Use of CAV in Determining Effects of Small Magnitude Earthquakes on Seismic Hazard Analyses

DRAFT Final Report, June 2006

In this report, we develop models for estimating the CAV and show how to use the CAV model to remove earthquakes that are not potentially damaging from the hazard analysis. The NRC sent 15 Requests for Technical Update on this subject (Combined NRC RAI Comments on EPRI

Figure 2-11
Magnitude Dependence of the CAV Residuals

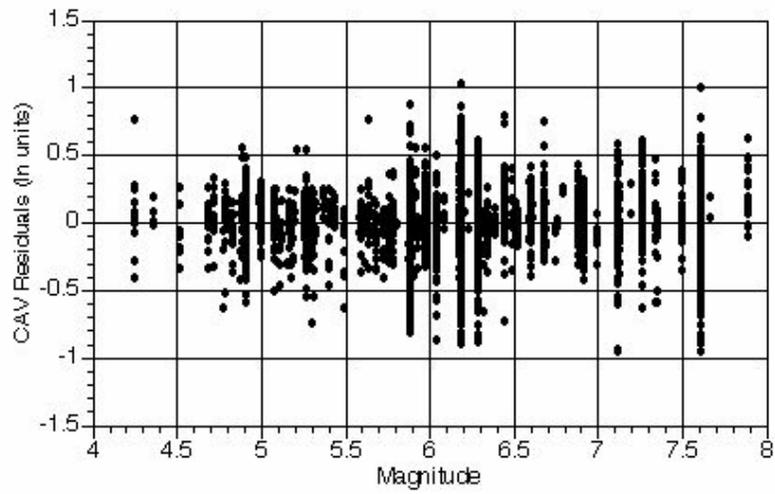
- 2.5 The report indicates that the CAV model based on WUS data strong motion data set is applicable to the EUS because no significant bias in terms of CAV residuals distribution for the CEUS (figure 2-11 in the report). The residuals are the estimates of experimental error obtained by subtracting the observed responses from the predicted response. How are the CAV distributions with respect to uniform durations and PGAs for the CEUS?

- 2.5 This Question was not clear and was clarified at the May 12 meeting. Plots of the CAV data from the EUS are plotted as functions of PGA and uniform duration. The plots of the EUS CAV data vs PGA and duration are shown below:

Figure 2. Time-History Records and Computed CAV Values Associated with the El Centro Steam Plant (Differential Array, 1979 Imperial Valley, CA Earthquake; closest record to plant)

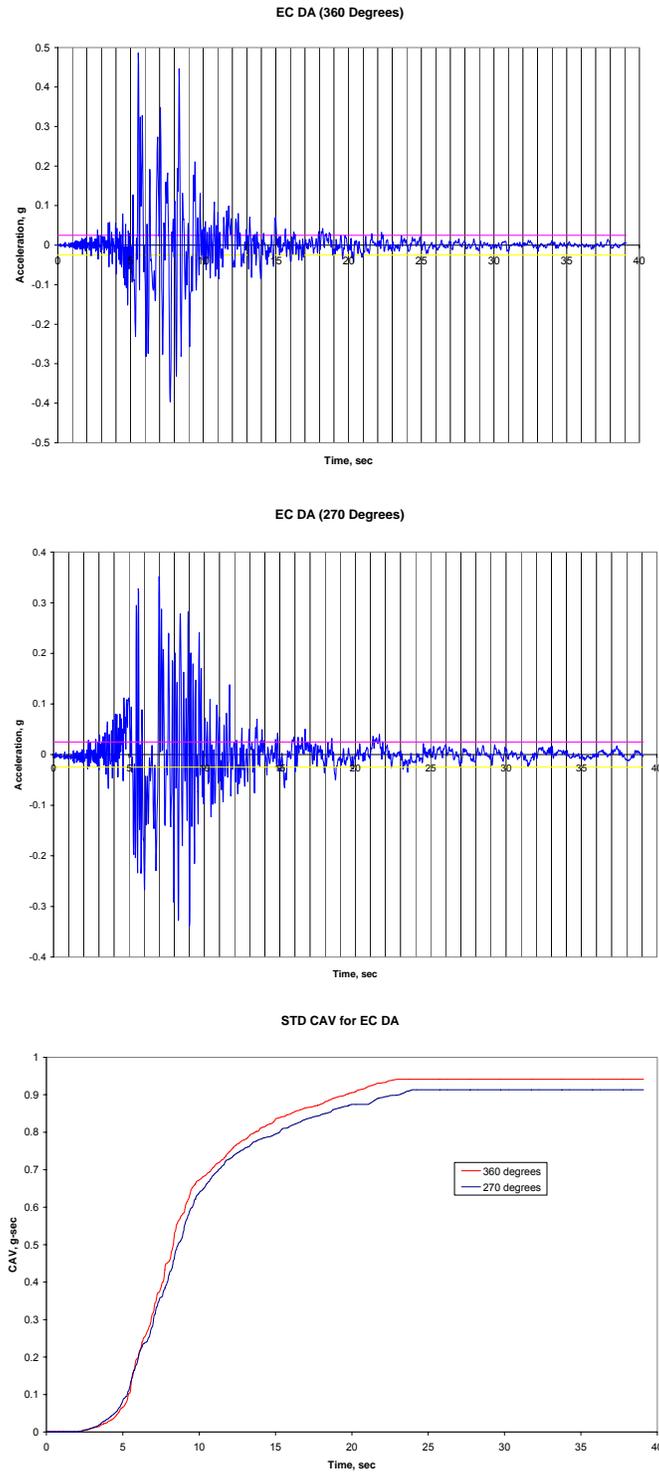
- a) ...”Please provide the basis for selecting the 0.16 g-sec threshold as a quantitative measure of no damage to structures, in view of the qualitative nature of assigning an MMI to a site”...“also please justify the limitation imposed by simplifying the complexity of ground motions into a single parameter of CAV.”
- b) “In view of the significant increase of strong motion earthquake recordings near industrial sites since 1980, please justify the continued usage of 0.16 g-sec as a conservative threshold for damage by providing examples from recent strong motion recordings...”.

As can be noted in Figure 2, the CAV for the El Centro Steam Plant includes the strong motion portion (5-10 sec) that contributes approximately 60% of the total CAV value. The remaining portion of the CAV value is due to the initial 2-5 sec rise time and the 10-23 sec decay time of the records. Thus, the computed CAV value is always larger than the strong motion contribution resulting in a conservative damage measure when used as a low bound exclusion criterion.

The damage threshold CAV value of 0.16 g-sec, selected in Reference 2, was based on the observed negligible structural damage associated with MMI VII for buildings of good design and construction. Since power plants have been subjected to earthquake motions with observed MMI VIII levels and have remained functional, the selected threshold CAV value of 0.16 g-sec which is associated with MMI VII can also be interpreted as a conservative measure of threshold functional damage. If a motion, either a design time-history or an actual acceleration record, is associated with a given power plant site, then we can state, with high confidence, that no functional damage should occur to components within that plant (given the primary caveats are satisfied, i.e. adequate anchorage, sufficient restraint, lack of spatial interaction, etc.). This is the underlying basis for the CAV threshold criteria included in Regulatory Guide 1.166 as an optional method for determining Operating Basis Earthquake exceedance in the case of a seismic event occurring in the vicinity of an operating nuclear power plant.

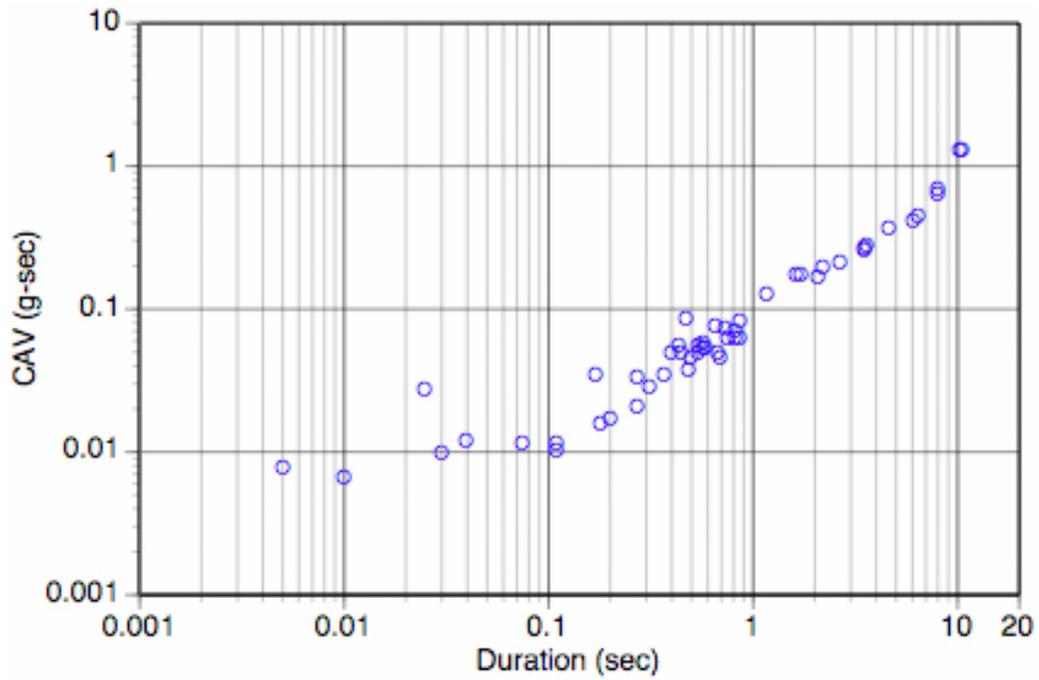
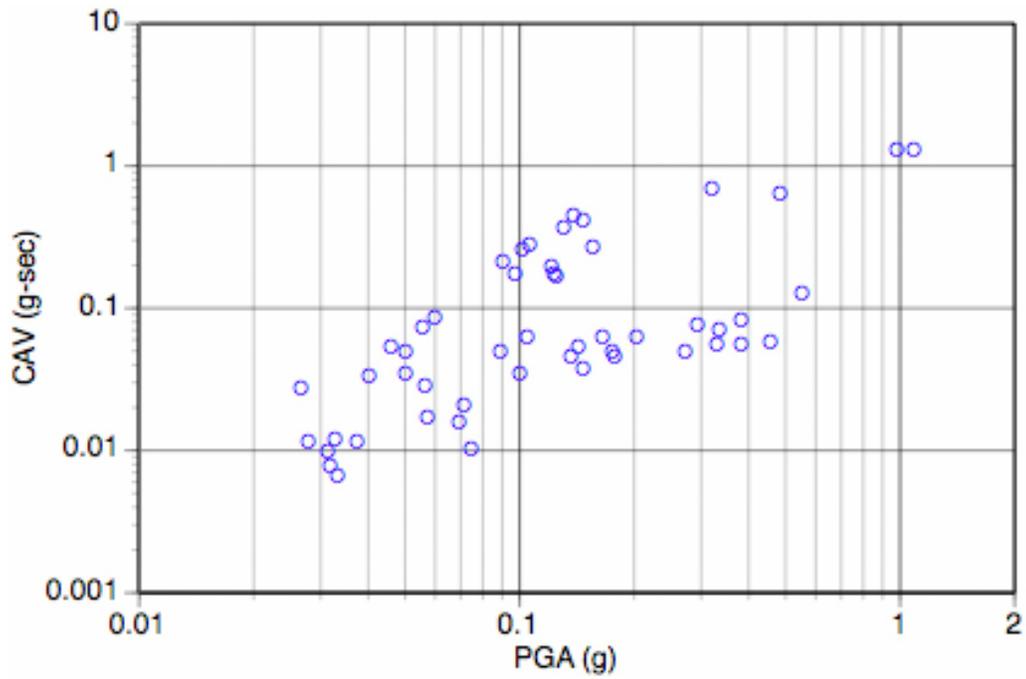
- 2.4 Since previous earthquakes have demonstrated that structural damage is closely correlated to surface soil type, if CAV is not sensitive to a soil type please explain how can it be used to as a single parameter for structural damage?

- 2.4 CAV is sensitive to soil type, but this is accommodated through the PGA dependence.
